Executive Director's Recommendation

Commission Meeting: July 9, 2015

Final Real Property Master Plan

U.S. Soldiers' and Airmen's Home
National Cemetery
Harewood Road, NW, Rock Creek Church
Road, NW and Clermont Drive, NE
Washington, DC

Figure 5: Master Plan Projects

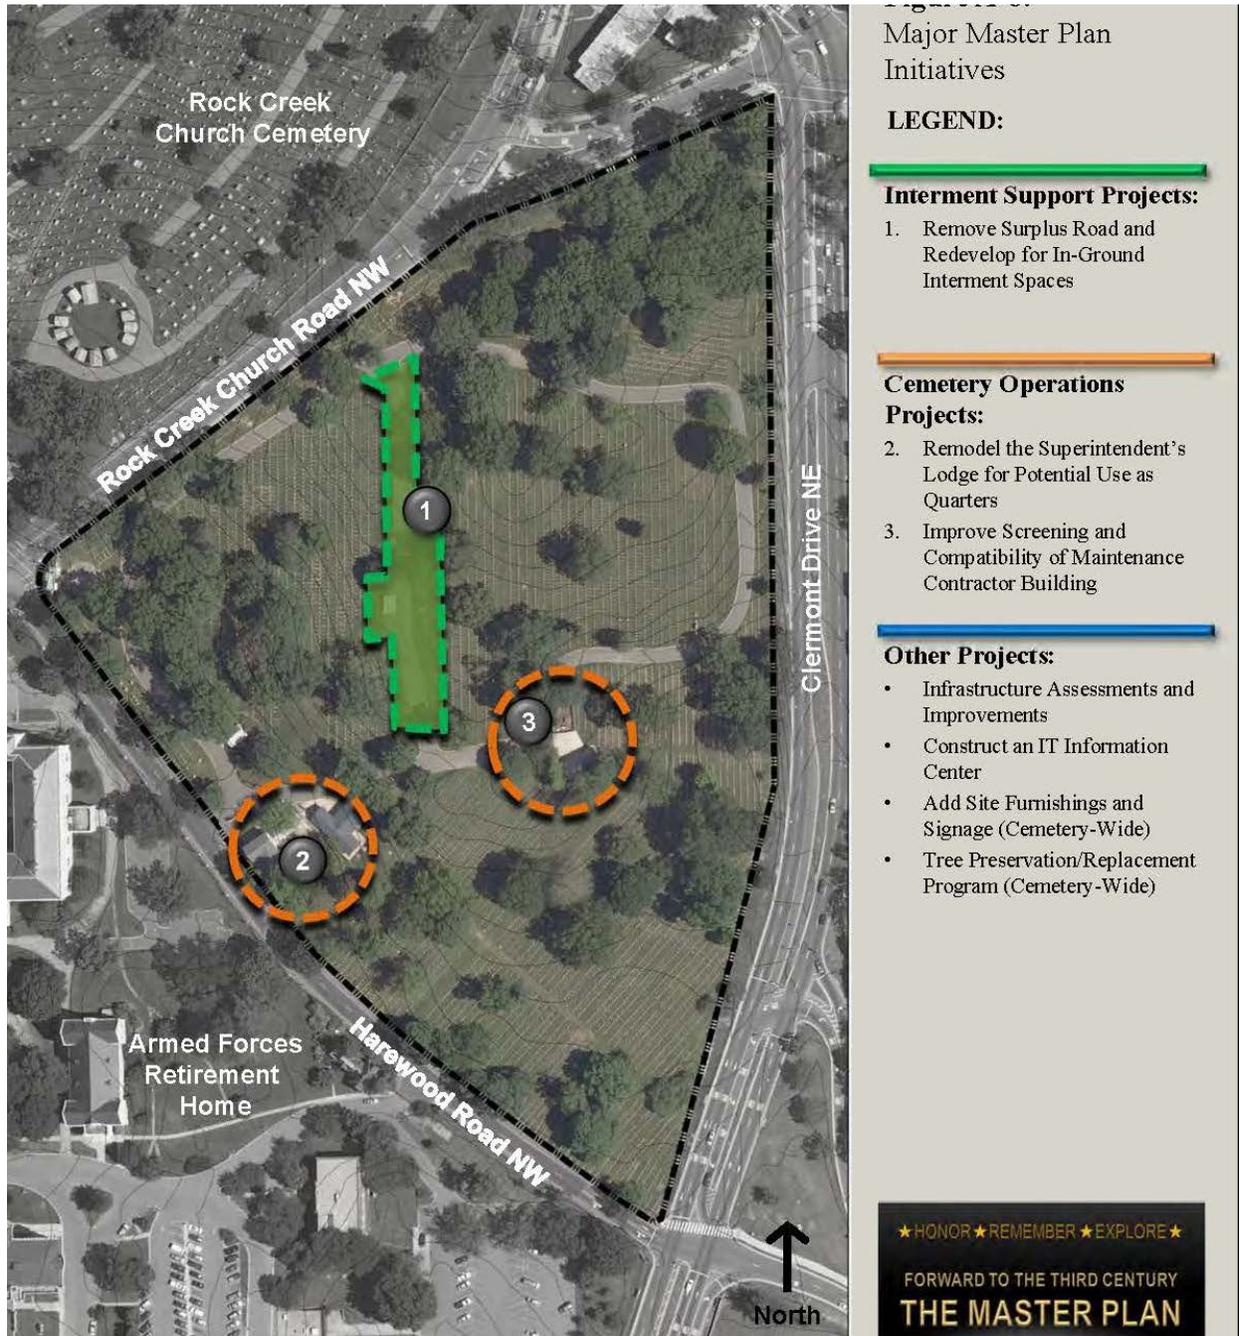
The Army has included the entire cemetery as a contributing historic element, therefore the proposal to remove the north-south roadway from the middle of the cemetery could affect archeological resources below it and the surrounding historic landscape. As part of the May 2015 Commission Action on the draft master plan, the Commission requested that the Army undertake further study to determine historic and archeological resources likely to be affected by the proposed removal of the north/south roadway. In a letter dated May 7, 2017, the Army responded that it will undertake further historic and archeological study if the proposed removal of this roadway proceeds. Staff is satisfied with the Army's response.
